### HISTORIC AND DESIGN REVIEW COMMISSION July 17, 2019

**HDRC CASE NO:** 2019-359 103 W GRAYSON ST **ADDRESS:** NCB 7007 BLK B LOT 5 **LEGAL DESCRIPTION: ZONING:** IDZ, RIO-2 **CITY COUNCIL DIST.:** 1 **DISTRICT:** Tobin Hill Historic District Lee Fordham/Harrison USA LLC **APPLICANT: OWNER:** TACOLAND STUDIOS LLC **TYPE OF WORK:** Construction of an addition, roof form modifications, window replacement, signage, exterior lighting, landscaping, painting, **APPLICATION RECEIVED:** June 21, 2019 August 20, 2019 **60-DAY REVIEW:** Edward Hall **CASE MANAGER:**

The applicant is requesting conceptual approval to:

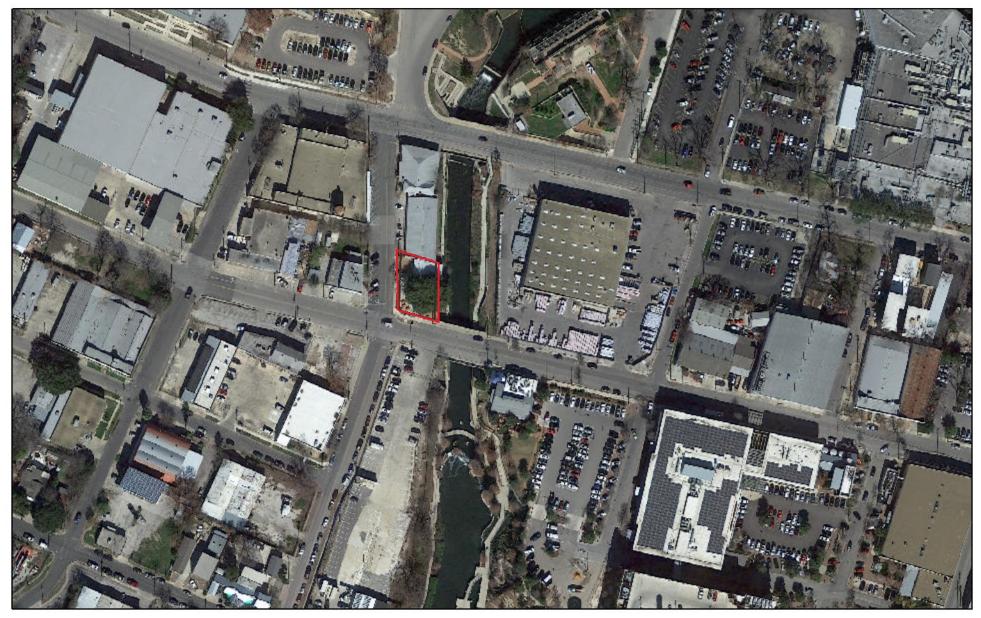
- f. COOLER ADDITION & EXISTING MURALS As proposed, a cooler and kitchen addition to the existing

corner structure will obscure or destroy two graffiti murals that were preserved per a previous HDRC action in 2012. This includes the letters reading "TACOLAND" and the Ram Ayala memorial. Staff finds that the previous decision to preserve these graffiti elements should be respected and that applicant should take steps to ensure that they remain visible to the public.
